Re: **Copper World and Water Resource Impacts East of the Santa Rita Mountains**

# **Copper World East of the Santa Rita Mountains**

Julia Fonseca, Madrean Resources

**Figure 1. Phase 1 open pits and waste rock disposal locations, relative to Hudbay's private property. Darkest lines represent locations of geological cross-sections (from Figure 62-1 March 31, 2023 map by Piteau)**

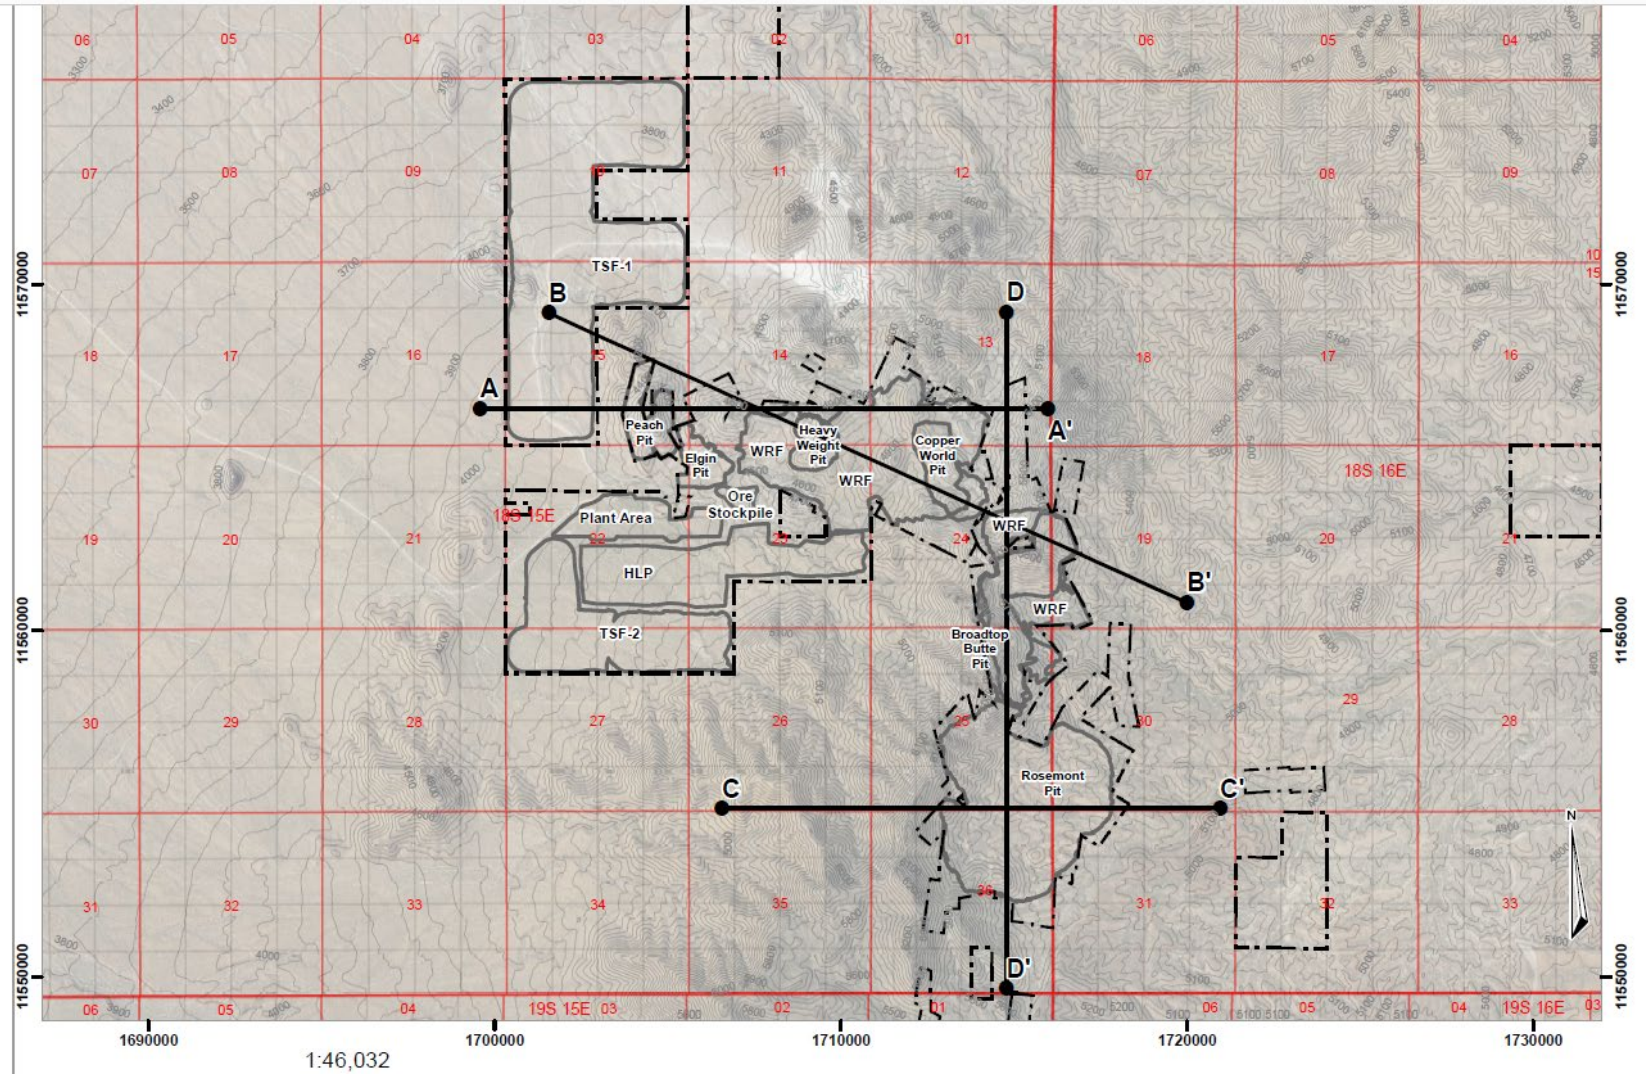
Figure 1 shows the location of all six proposed pits and waste rock facilities (WRFs) associated with the Phase 1 Copper World proposal in relation to the private land owned by Hudbay. The current design reflects the relocation of mineral processing operations proposed in the Rosemont EIS, as well as the initial disposal of tailings, to the west side of the crest. Phase 1 pit excavations and waste rock disposal would still occur east of the crest.

**Figure 5. Broadtop Butte and East/Rosemont pit features relative to local geology as referenced in cross-section D-D' of Figure 1. (Piteau Associates)**

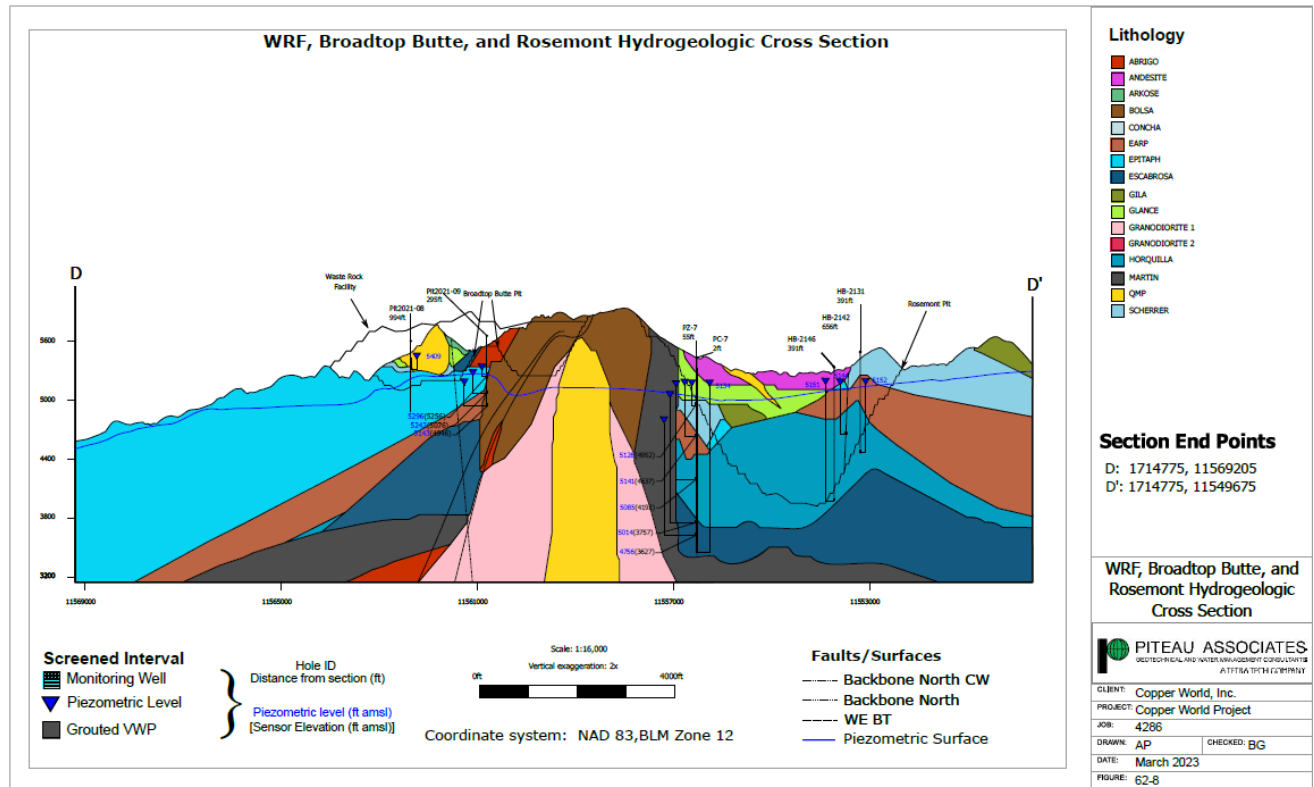
The Phase 1 East/Rosemont pit extends to a much deeper level than the Broadtop Butte pit. Note the “piezometric surface” as shown on Figure 5; this is the level to which groundwater currently rises in boreholes. Both pits would penetrate below the water table into alluvial and limestone aquifer materials, but only the Broadtop Butte pit would be backfilled.

Even during Phase 1, the depth of the pit, the type of material intersected, and the steepness of the East/Rosemont pit walls would require a substantial groundwater pumping operation at the East/Rosemont pit to “dewater” the geologic formations that would be penetrated. Hudbay’s 2023 Preliminary Feasibility Study for Copper World (PFS) and more recent communications with County staff during the June 2026 field tour indicate that dewatering would commence during the earliest phases of construction. Dewatering is done to prevent flooding of the pit, increase pit wall stability, and improve worker safety (Figure 7). Much of the dewatering would occur during the first two years to reduce pore pressures in the formations prior to excavation.

**Figure 6. Rosemont or East pit geological cross-section C-C' as marked on Figure 1 (Piteau Associates)**

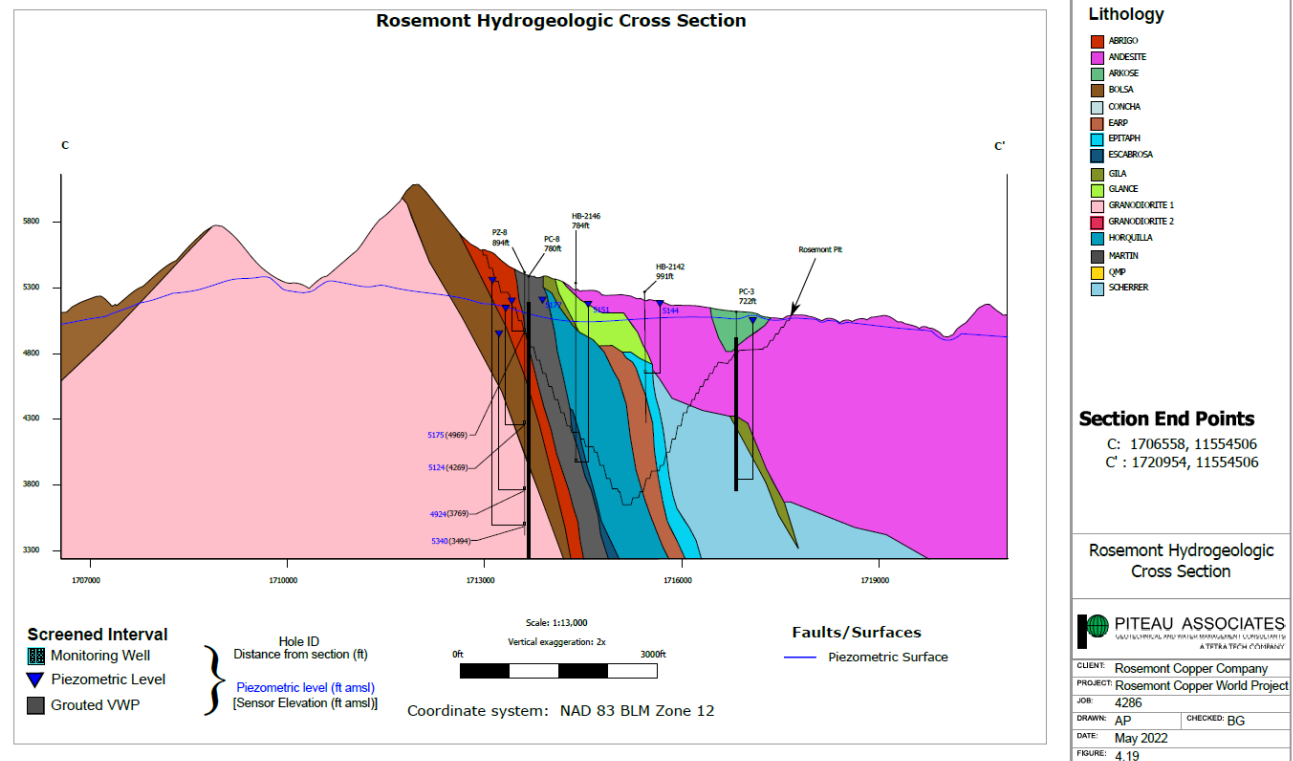
For a closer look at the East/Rosemont pit, see Figure 6 cross-section. The Phase 1 pit wall would impinge on the high slopes of the mountain (Figure 6). The Phase 1 wall facing Highway 83 would be much more visible than described in the Rosemont Copper EIS, unless and until Phase 2 waste rock and tailings would be stacked high enough to obscure the sightlines.
